Ref: 21/02083/REM

I am commenting on the above application from an arboricultural aspect.

Site - Tapper Farm - Bodicote

Proposal – to demolish existing buildings and building 46 dwellings

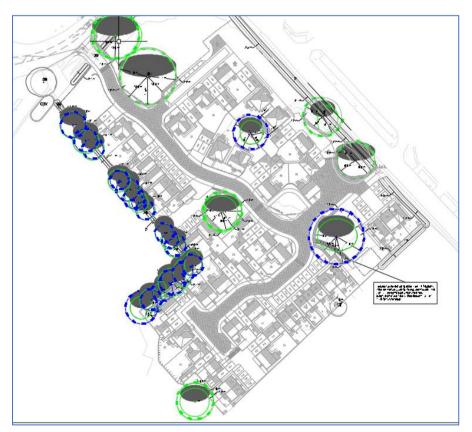
- 6. All RPAs have been applied as circles and have not allowed for pre-existing site conditions, ie buildings and roads. As per clause 4.6.2 of BS5837:

This reflects mainly to the oak tree T3, beech trees T4 and T40.

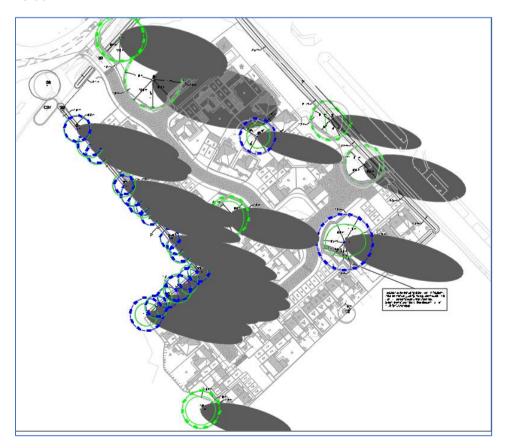
7. I have used the measurements provided to provide the following shadow modelling for various times of the day, based on the 21st June.

- 8. The above shadow modelling clearly illustrates the impacts to the proposed locations of properties 21 to 36, where they are in shade from midday onwards. Although comments were made about the shadowing impacts in 3.5.2 of the tree report no mitigation recommendations were made.
- 9. A simple fix to this problem would have been to use the existing access road, which runs along the boundary under the canopy of the neighbouring trees, to service the site and move the properties further back from the trees.
- 10. As has been mentioned earlier the RPA of some trees has not been properly plotted in line with recommendations of BS5837. By offsetting the RPA of the category A oak tree T3 the % encroachment of the hard surface has increased dramatically.

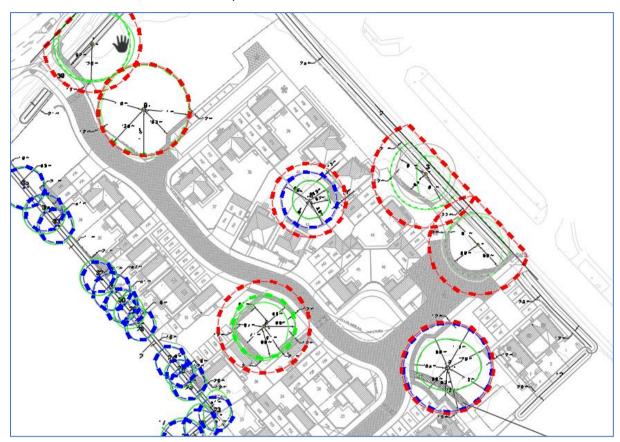
11. Severe pruning is proposed to the category A beech tree T4 due to the encroachment of the proposed new road. This is not acceptable for a tree of this significance.

12. The plan below illustrates the required RPAs (in red) to allow for future growth of the trees. Also it is not possible to ensure the TPO tree T8 is properly protected in the long term being located in the rear of 4 separate gardens. It should be in an open space. The RPA of the these protected open space trees should be protected by railings to ensure vehicles do not use those areas to cause compaction.
